TENNESSEE VALLEY AUTHORITY

SUBJECT: KINGSTON STEAM PLANT - ANNUAL ASH DISPOSAL AREA INSPECTION

FEP '840912 003

SUBJECT: KINGSTON STEAM PLANT - ANNUAL ASH DISPOSAL AREA INSPECTION

④ OUTLET/DISCHARGE
STRUCTURE

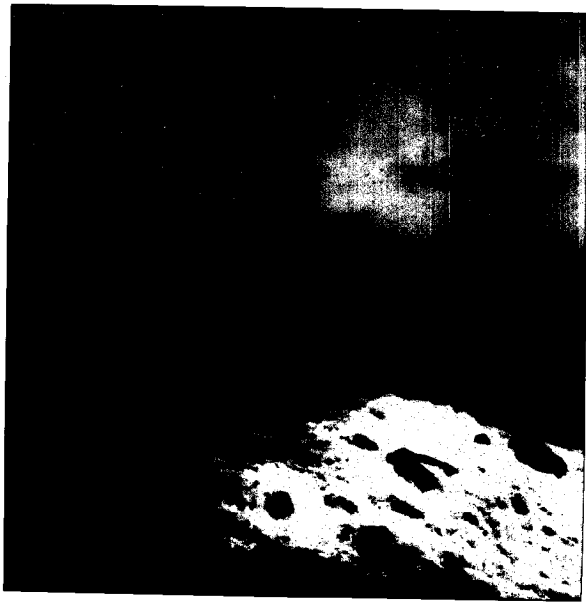
All discharge outlets are operating properly and unrestricted.

Additional and larger recommended stone was added at the base of the outlet structure.

⑥ REMAINS OF FAILED INTERDIAPHRAGM
DIKE FOR DREDGED ASH
CONTAINMENT

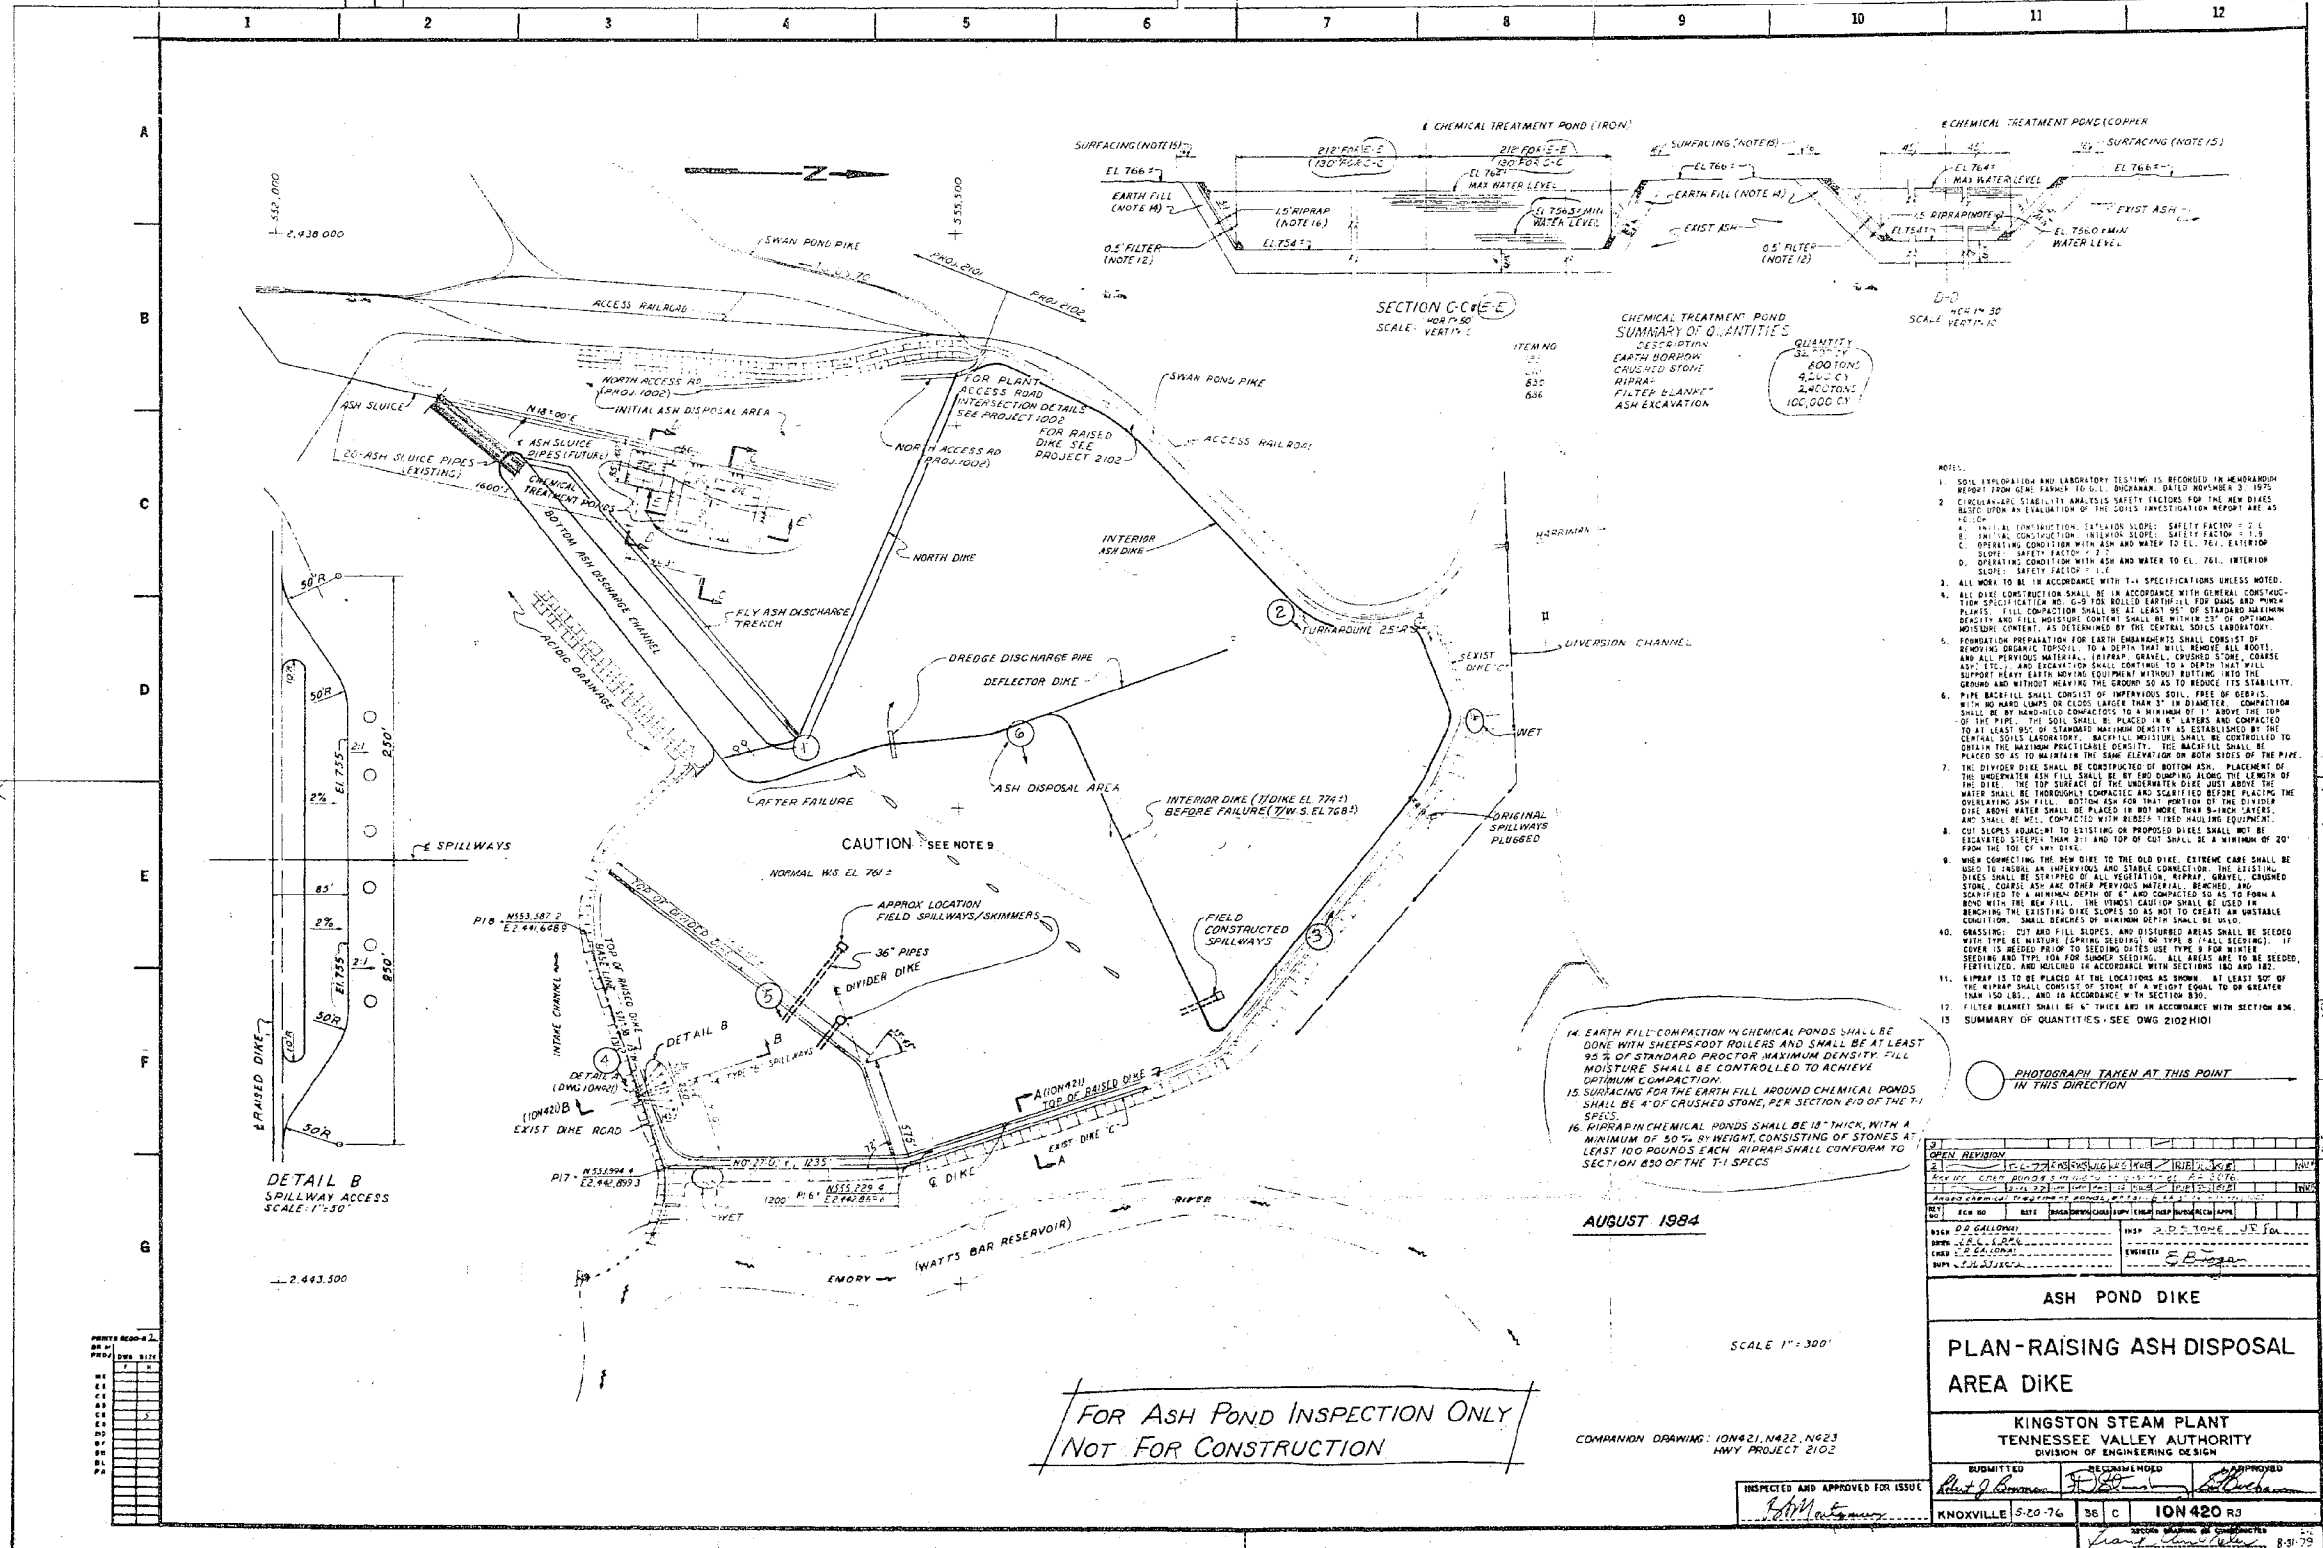
The exterior dikes appear to be structurally stable. Wetness is still evident at the toe of the south end of dike "C." A soils investigation, EN DES Soil Schedule 82.3 dated May 1984, of this area indicated a bottom ash base for the raised dike (construction 1977) is most likely the avenue of the seepage (see recommendation No. 1).

Pooled water at the base of the raised dike was also observed at the north end of dike "C." This area is indicated on the attached drawing 10N420 (see recommendation No. 1).

F&H PR constructed an interior ash dike for the containment of material dredged by a private contractor. On the morning of August 8, a failure of this dike resulted in the loss of much of the dredged material to the previously dredged area (see attached print of 10N420). With the sudden rise in the water/ash elevation, the plant constructed spillways and skimmers were inundated, thus discharging floating ash into the stilling pool.

1. Plant personnel should continue to monitor the seepage at the indicated locations and contact F&H PR, Chattanooga, and EN DES immediately if any apparent changes are observed.
2. Should remove all small trees and brush from exterior slopes.
3. Slope stability analyses of the exterior dikes should be performed to ensure their stability before any additional loads (dredging or stacking) are incurred. Engineered interior dikes could reduce the risks of their failure also.
